Service Bulletin

Bulletin No.: 13-06-01-003C

Subject: Excessive Oil Consumption – Perform Oil Consumption Test and/or Install Piston and Piston Ring Kit

Models: 2010-2013 Buick LaCrosse
2011-2013 Buick Regal
2010-2013 Chevrolet Equinox
2010-2013 GMC Terrain
Equipped with 2.4L Engine (RPOs LAF, LEA)

3339530

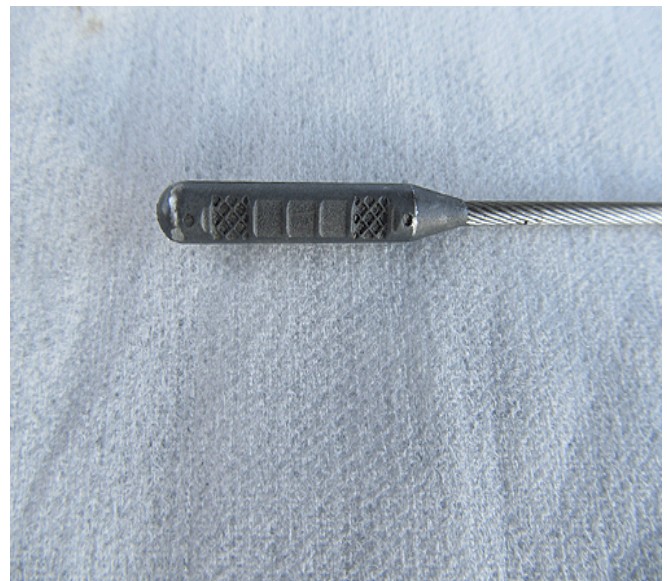
Important: When checking the oil level with the oil dipstick design shown below, please note that the oil volume per notch is not linear due to the shape of the block. The upper notches (relative to the top of the handle) equal 0.24 quart (0.227 L) between each notch while the lower notches only equal 0.14 quart (0.132 L) between each notch. As a result, no oil will appear on the dipstick if it is low on oil by approximately 1.25 quarts (1.18 L) or more. When determining the oil consumption rate, the oil volume added to return it to the starting location is the total amount of oil consumed. The consumption rate must be documented on a repair order.

Notice: Do not add too much oil. An overfill can lead to burn off of the excess oil. Advise the customer to wait until the oil is below the cross-hatched area at the tip of the dipstick before adding oil.

Acceptable Cylinder that Does Not Appear Uniform (Zebra Stripes)

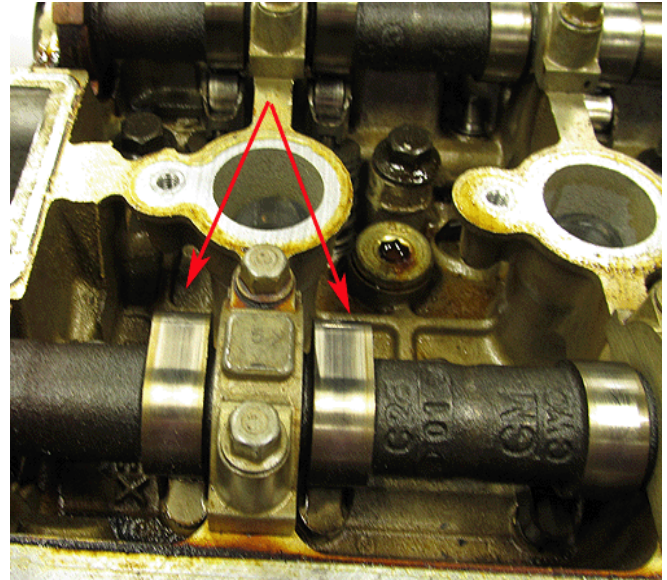
The repair is to replace the pistons and rings. In some cases the bore surface may not have a uniform look to the finish (zebra stripes) as shown below. As a result, some technicians may question whether the engine should be repaired or replaced. After careful evaluation, GM Powertrain has determined that the new pistons and rings will perform correctly in bores that have this appearance so engine replacement should not be necessary. The cylinder bores do not need any machine or honing work performed on them. Refer to the picture below for acceptable surface finishes.

3409678

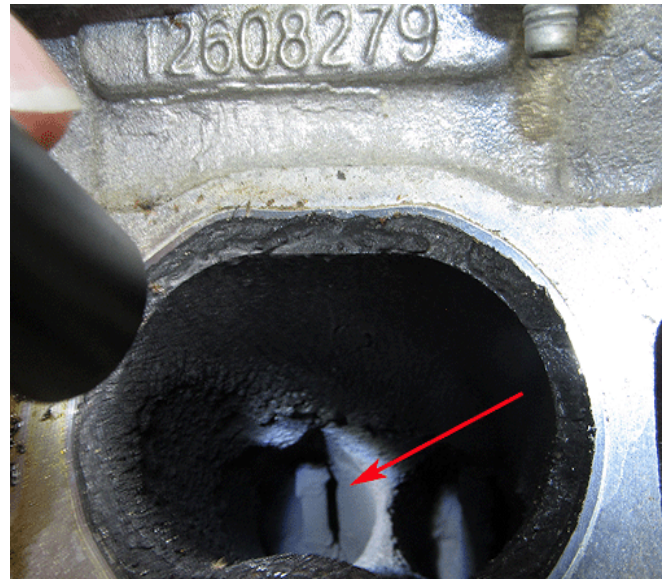
- Camshafts and roller follower will have wear markings. This is normal and do not need to be replaced (refer to picture above).
